Access Compliance Report

Public Rights-of-Way

(Curb Ramps)

Intersection ID: 15242	Main Street: E_INDEPENDENCE_BV	Cross Street: N_WENDOVER_RD_RA	Location: N
ADA ID: 76B36BB34706	Ramp Type: BlendTrans1	Initial Pass/Fail: Fail	Overall Compliance: No
		Severity Score: 10

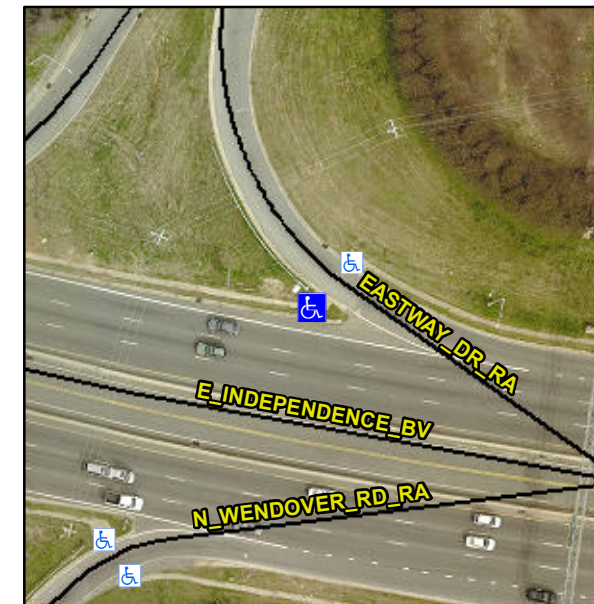
Not Found, R304.5.1, R304.5.3

Compliance	Description	Data	Compliance	Description	Data
N/A	Ramp Length (in)	73.0	Yes	BlendTrans Slope (%)	3.3
No	Ramp Width (in)	38.5	No	BlendTrans XSlope (%)	2.2
N/A	Flare Type LT	N/A	N/A	Flare Type RT	N/A
N/A	Flare Slope LT (%)	N/A	N/A	Flare Slope RT (%)	N/A
N/A	Flare Traversable LT?	N/A	N/A	Flare Traversable RT?	N/A
N/A	Landing Length (in)	N/A	N/A	DWS Provided?	N/A
N/A	Landing Width (in)	N/A	N/A	DWS Contrast?	N/A
N/A	Landing Slope (%)	N/A	N/A	DWS Length (in)	N/A
N/A	Landing X Slope (%)	N/A	N/A	DWS Full Width?	N/A
N/A	Landing Curb? (Y/N)	N/A	N/A	DWS Offset (in)	N/A
N/A	Shared Landing?	N/A			
N/A	Gutter Ponding?	N/A	N/A	Gutter Slope (%)	N/A
N/A	Gutter Lip Ht (in)	1.0	N/A	Gutter X Slope (%)	N/A
N/A	Painted X Walk1?	No	N/A	Painted X Walk2?	N/A
	X Walk 1 Direction	To NE		X Walk 2 Direction	N/A
	X Walk 1 Width (in)	N/A		X Walk 2 Width (in)	N/A
	X Walk 1 Slope (%)	8.6		X Walk 2 Slope (%)	N/A
	X Walk 1 X Slope (%)	0.3		X Walk 2 X Slope (%)	N/A

N/A	Ramp inside XWalk1?	N/A	N/A	Ramp inside XWalk2?	N/A
	Road Slope (%)	0.3		Clear Space?	N/A
	Road X Slope (%)	8.6	N/A	Clear Space to XWalk (in)	N/A
N/A	Any Obstructions?	N/A	N/A	Storm Grate/Utility Hazard?	N/A
	Obstruction Type			Storm Grate/Utility Type	
		N/A			N/A
			Yes	Surface Condition? (G/P)	Good
			No	Curb Slope (%)	13.6

Remove & Replace Curb Ramp With Two New Directional Ramps or Equivalent.
